Re: Letter of Transmittal – Onondaga Lake Repository Addition

Re: SCA West Basin - Design Concepts and Operation Plan, Dated October 2013

SCA WEST BASIN – DESIGN CONCEPTS AND OPERATIONS PLAN

**Honeywell International, Inc.
Sediment Consolidation Area
Syracuse, NY**

pH ADJUSTMENT TANKS ISOMETRIC

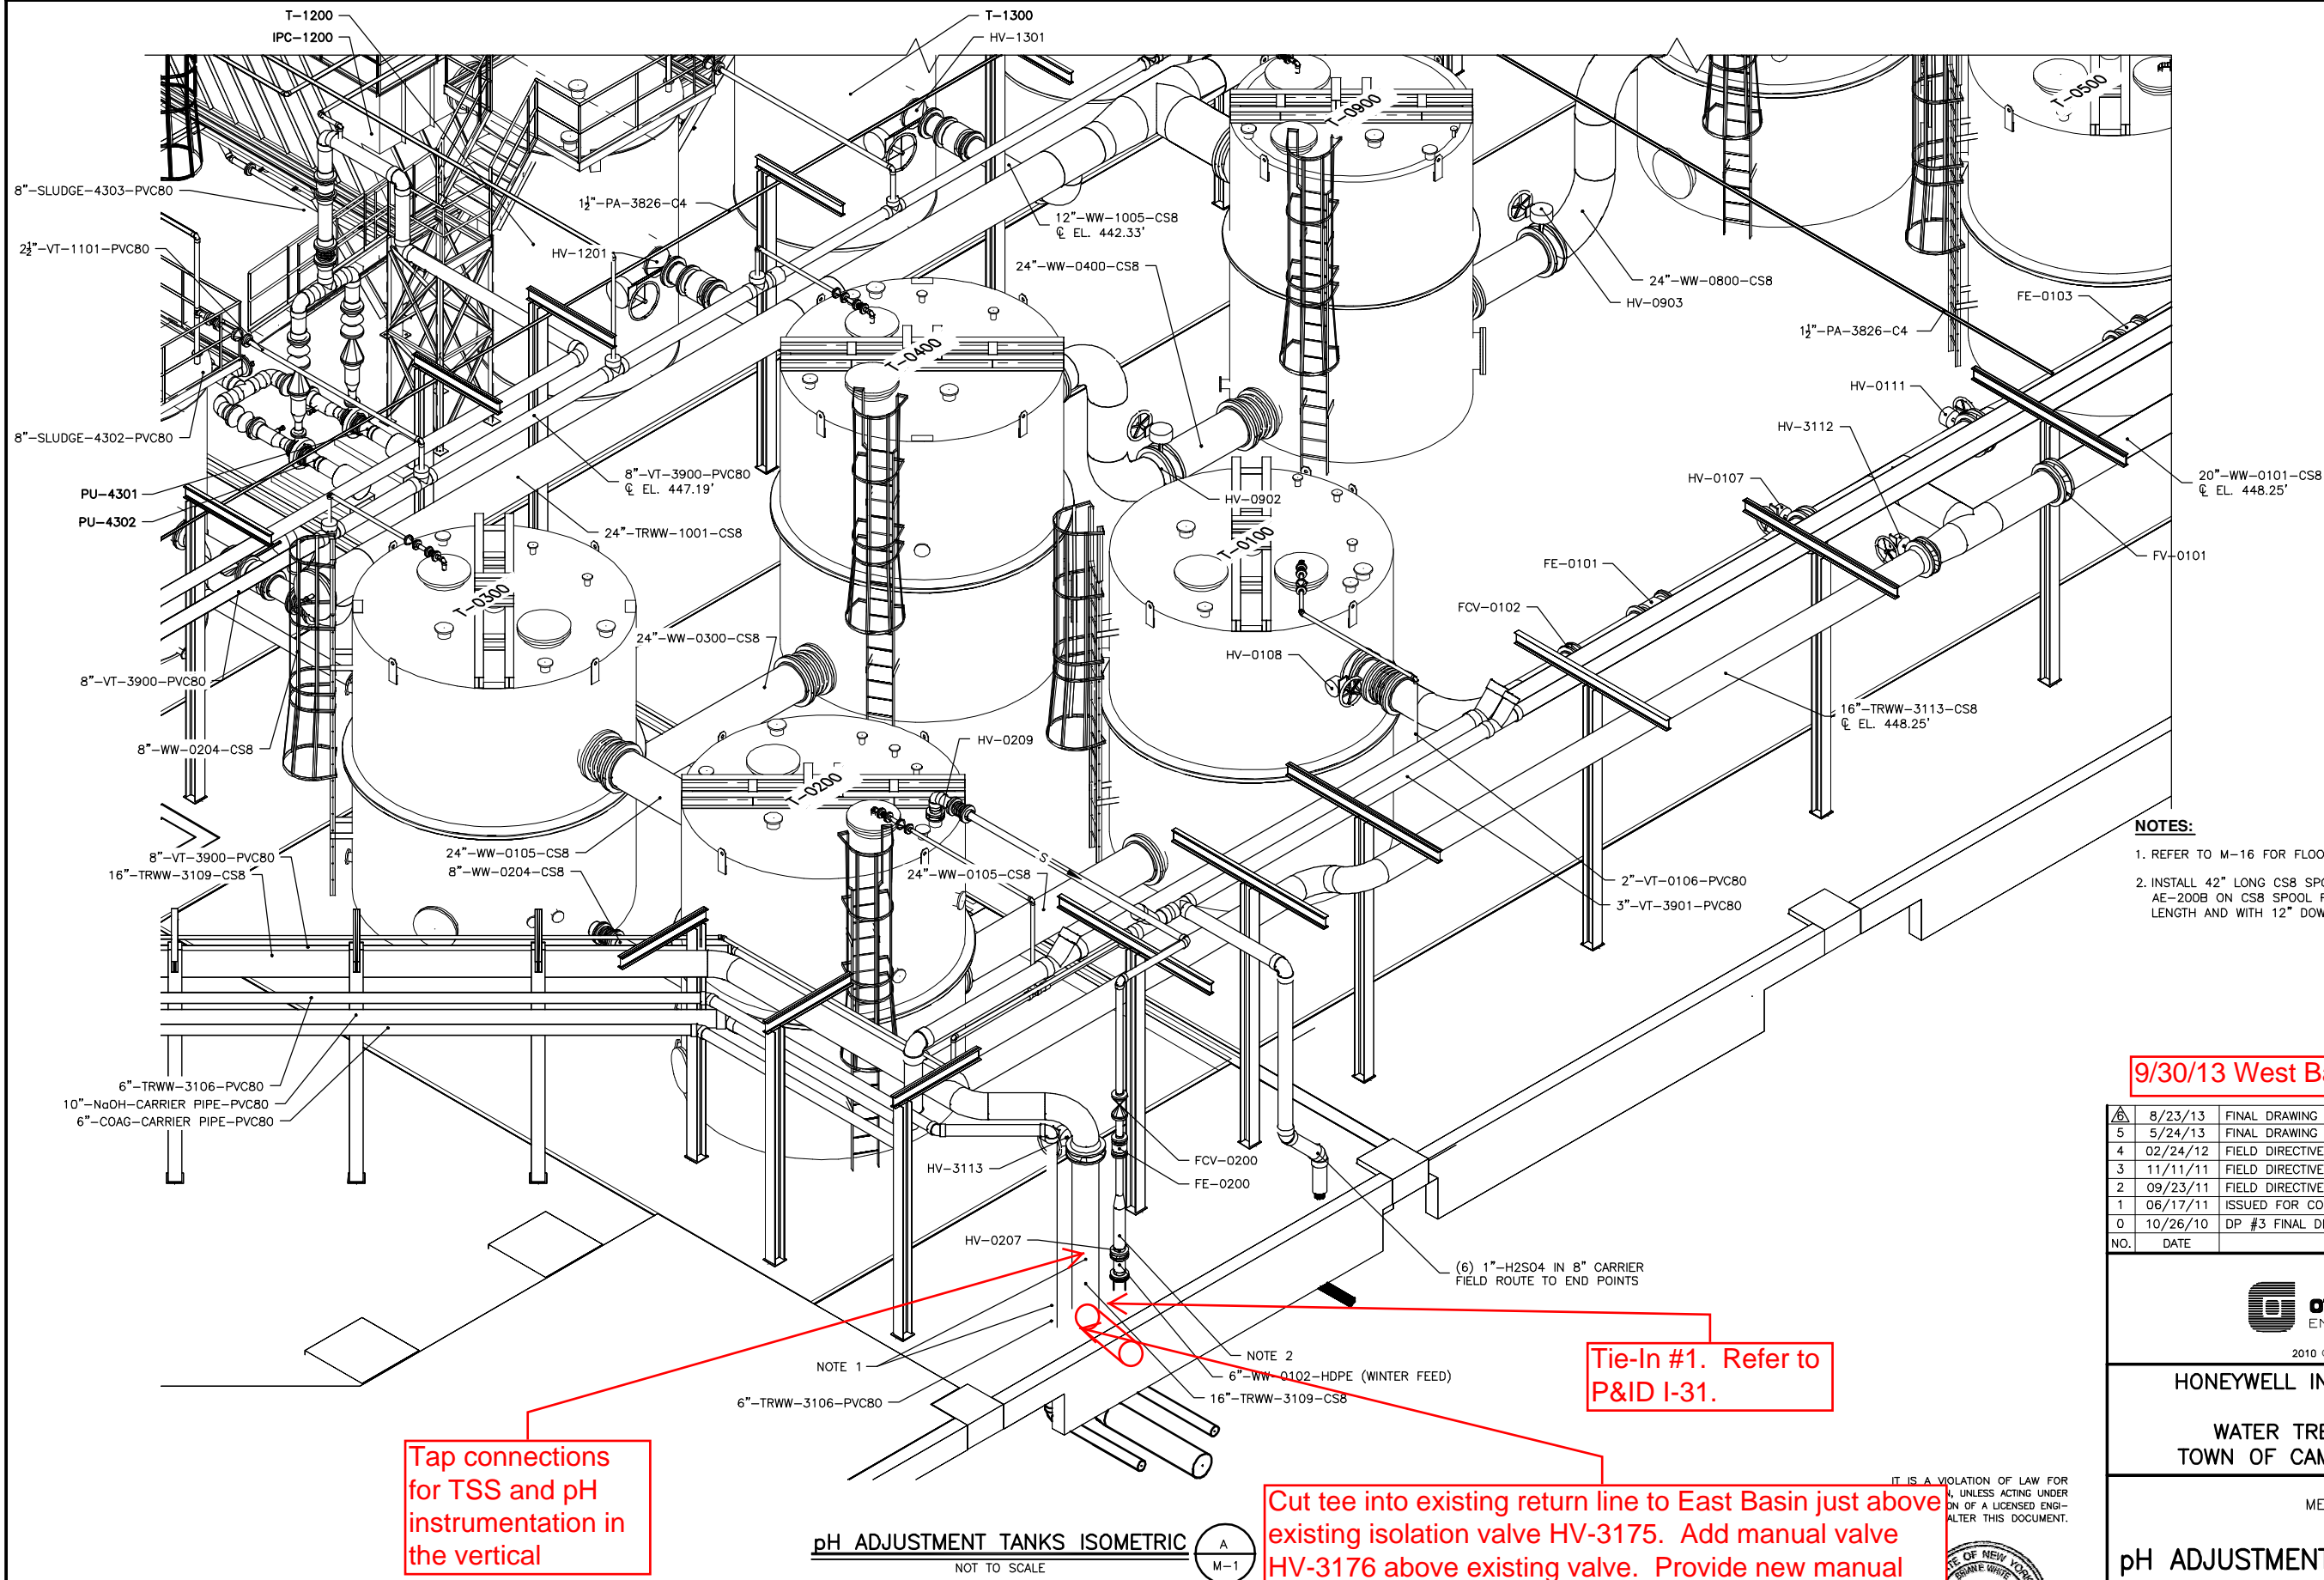
9/30/13 West Basin Modification

Tap connections
for TSS and pH
instrumentation in
the vertical

Tie-In #1. Refer to
P&ID I-31.

Cut tee into existing return line to East Basin just above
existing isolation valve HV-3175. Add manual valve
HV-3176 above existing valve. Provide new manual
valve HV-3177 on the new line exiting the building.
End the new line outside the building with a flange for
connection by others.

WEST BASIN PIPELINE PLAN

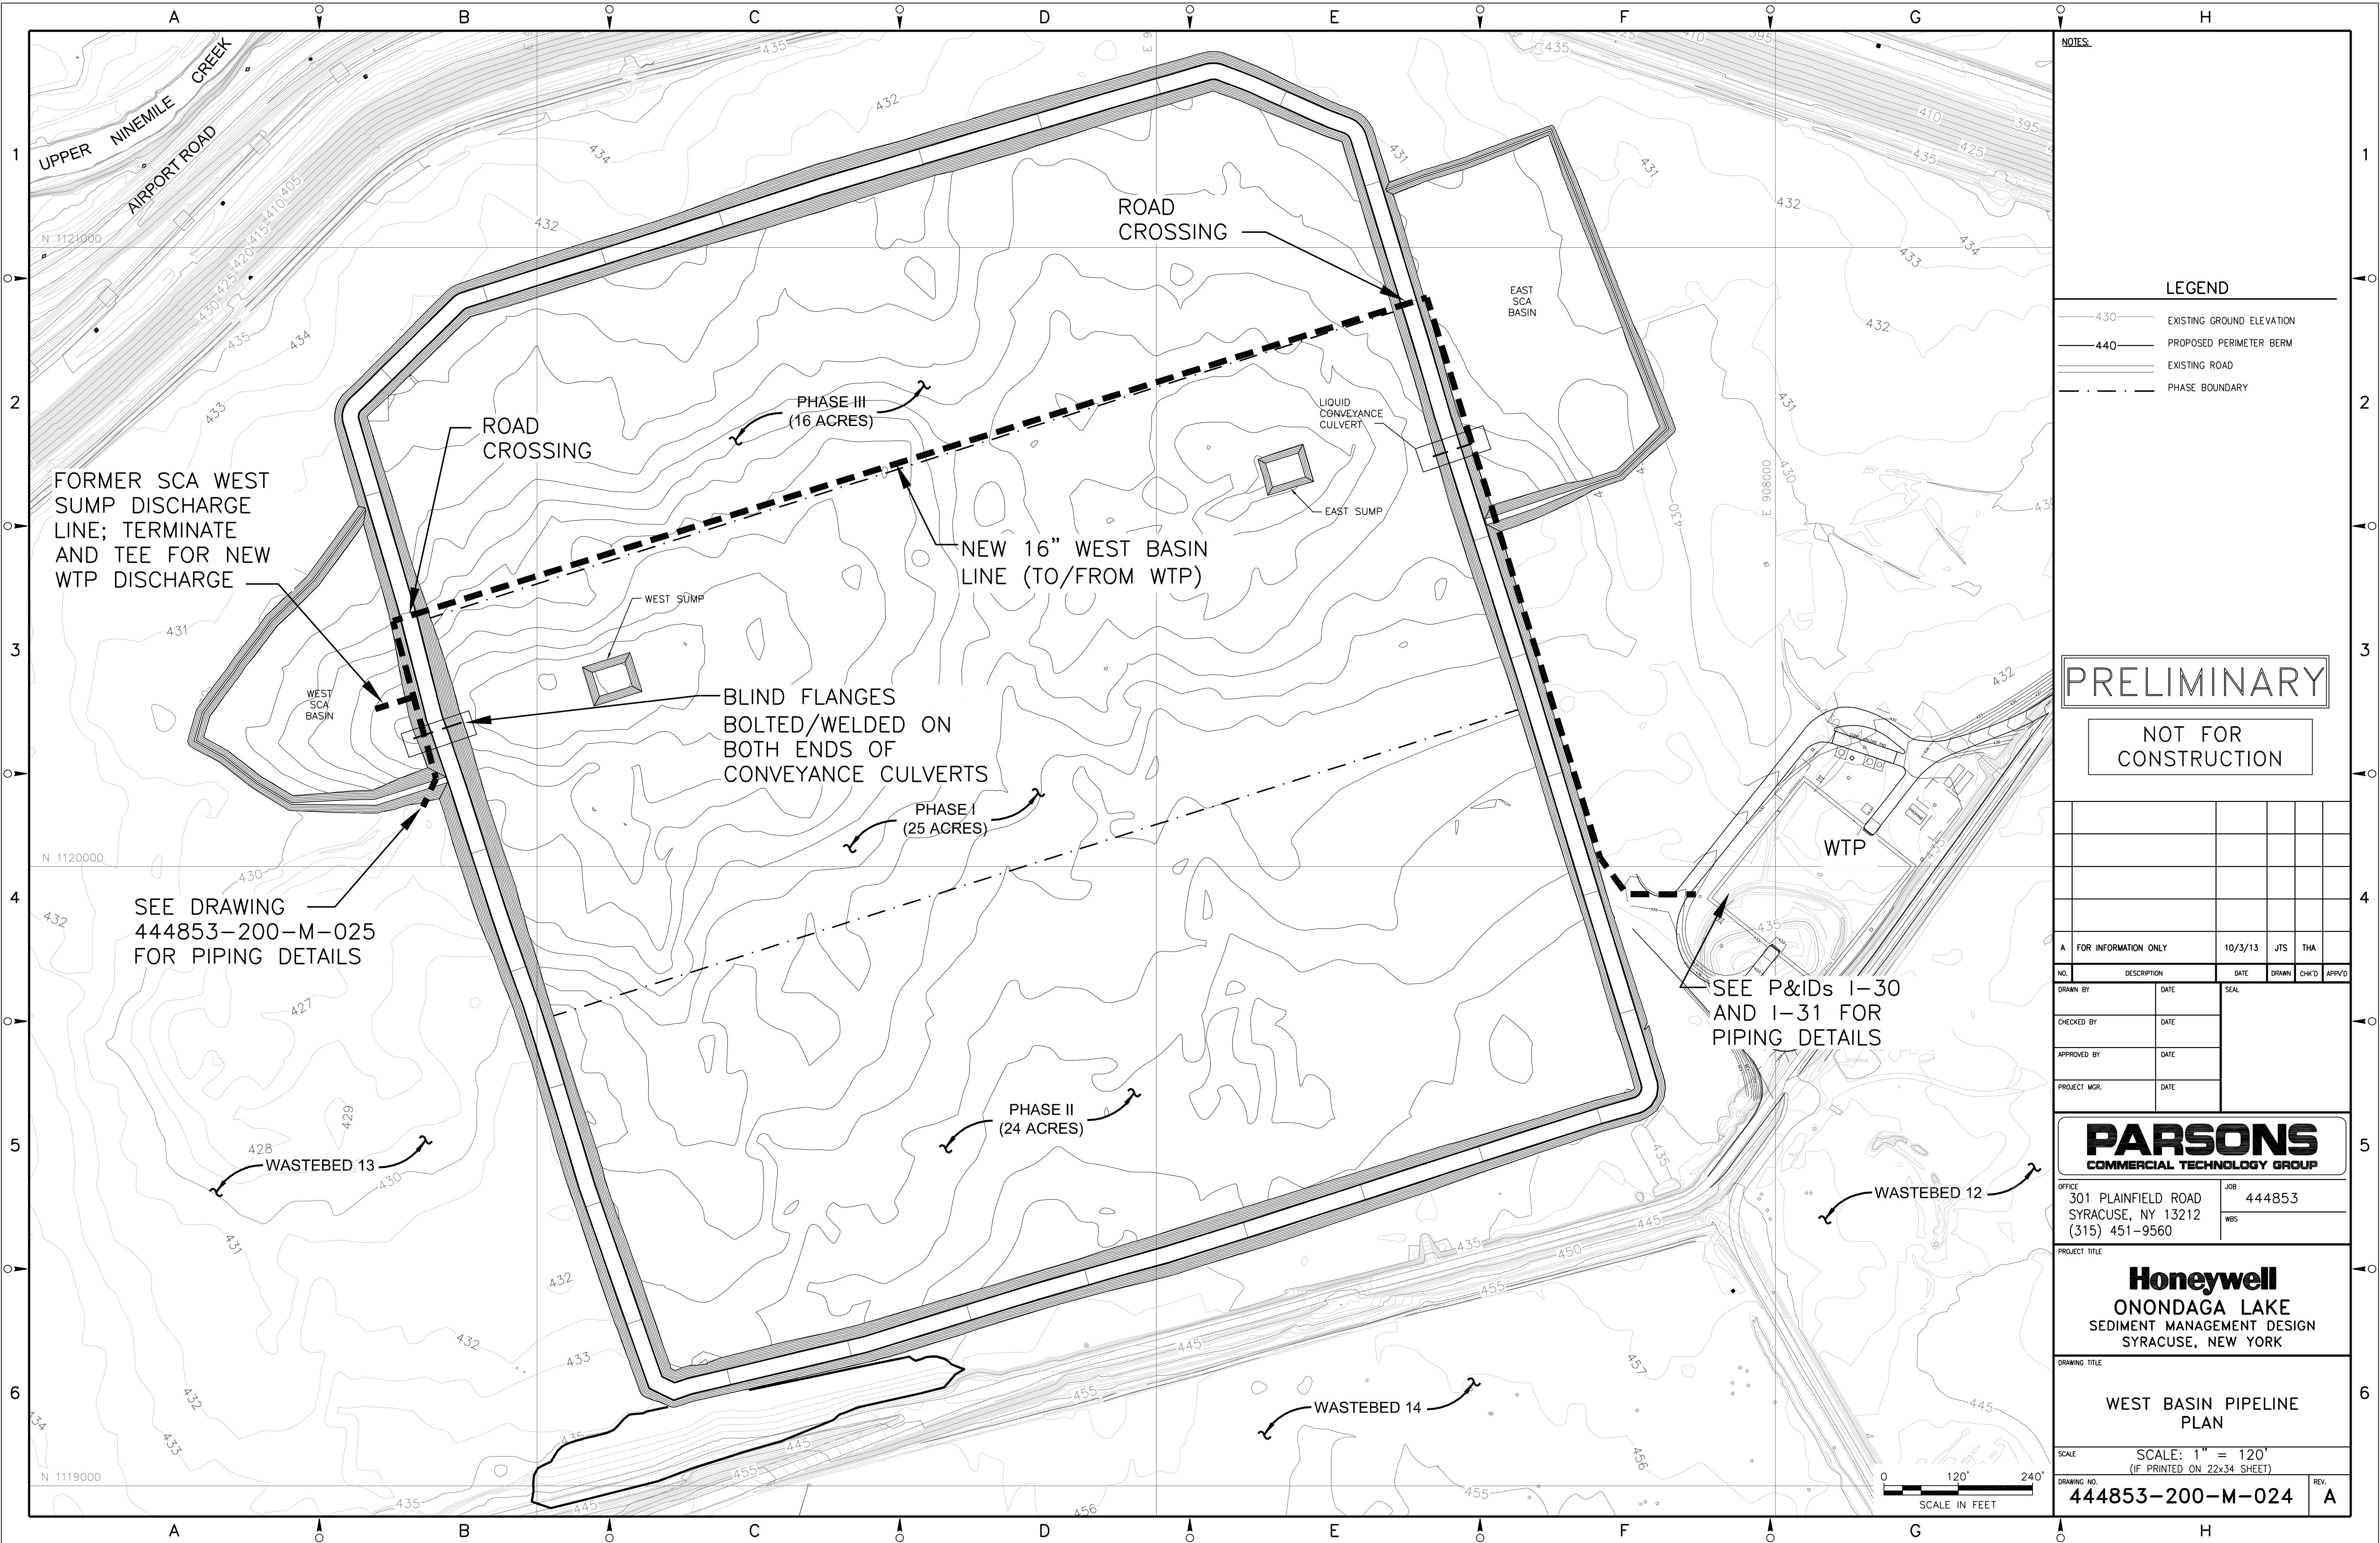
The general routing between the West Basin and the WTP is depicted on drawing 444853-200-M-024. Additional tie-in(s) will be performed at the West Basin as shown on 444583-200-M-025. The discharges from the existing Godwin pumps at the West Basin will be tied into the new 16" polyethylene line to the WTP.
